Cree® LM1 Series Product Change Notification

PCN Reference Number: CREE-PCN-0666
Date Issued: 11/2/2018

The pictures below show the dimension changes:

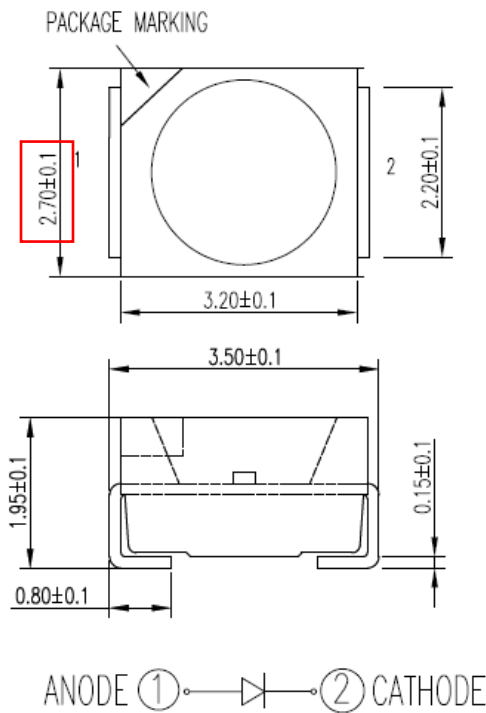
The leadframe and chip of LM1 red and amber LEDs have changed and the leadframe of LM1 green, blue and white LEDs have changed. The size, dimension drawings and product photos in the data sheets have changed. The specification of the above product series has changed. The order codes have not changed. Please refer to the latest data sheets on www.cree.com.

Cree Part Number	Current size (mm)	New size (mm)	Cree Part Number	Current size (mm)	New size (mm)
CLM1B-AKW	3.2 x 2.7	3.2 x 2.8	QLM1B-AKW	3.2 x 2.7	3.2 x 2.8
CLM1B-RKW	3.2 x 2.7	3.2 x 2.8	QLM1B-RKW	3.2 x 2.7	3.2 x 2.8
CLM1B-BKW	3.2 x 2.7	3.2 x 2.8	QLM1B-BKW	3.2 x 2.7	3.2 x 2.8
CLM1B-GKW	3.2 x 2.7	3.2 x 2.8	QLM1B-GKW	3.2 x 2.7	3.2 x 2.8
CLM1C-WKW	3.2 x 2.7	3.2 x 2.8	QLM1C-WKW	3.2 x 2.7	3.2 x 2.8
			QLM1D-GKW	3.2 x 2.7	3.2 x 2.8
